# ADDENDUM NO. 1

**PROJECT NAME: Surf Road NRCS Drainage Improvements**

**PRI PROJECT NO: 203.108 --- Wakulla Co ITB #2014-03**

**Surf Rd. NRCS Drainage Improvements**
**Questions & Answers – FINAL LIST**
**ITB #2014-03**

| CHECKED: | S3 |

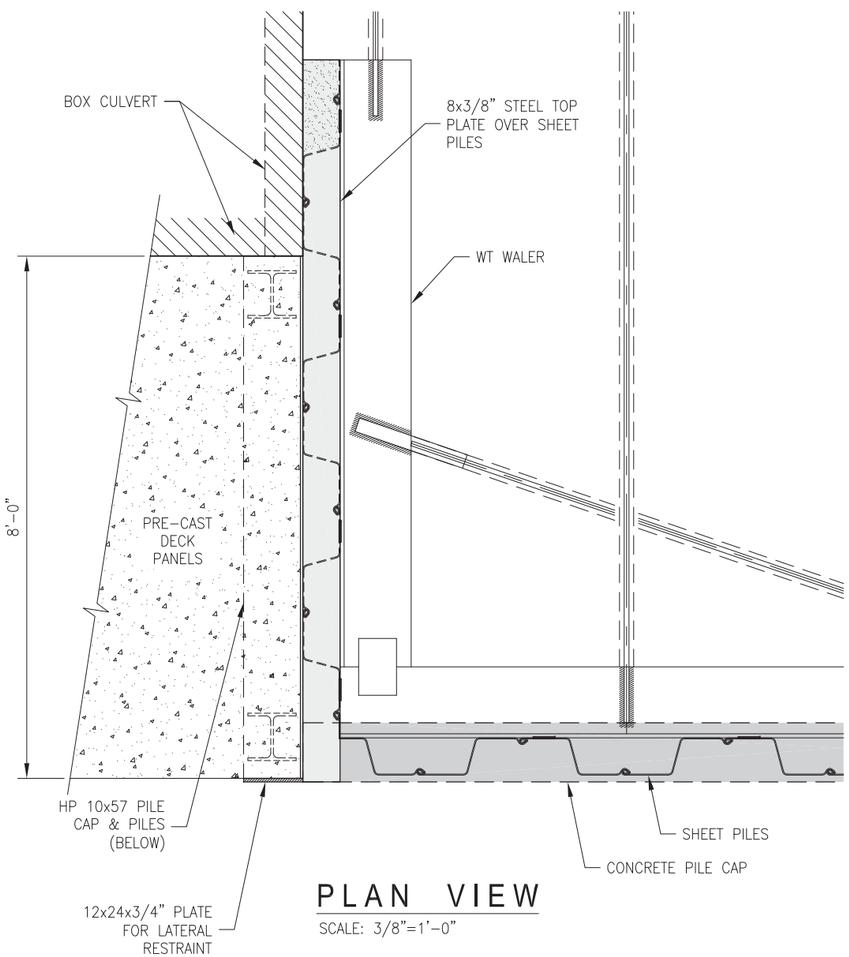
Q. Sheet S-3 – Section A-A shows an HP 12x63 cap while B-B shows an HP 10x57. Please advise which is correct.

***A. The proposed pile cap is required to be HP 10x57. Please see the revised plans.***
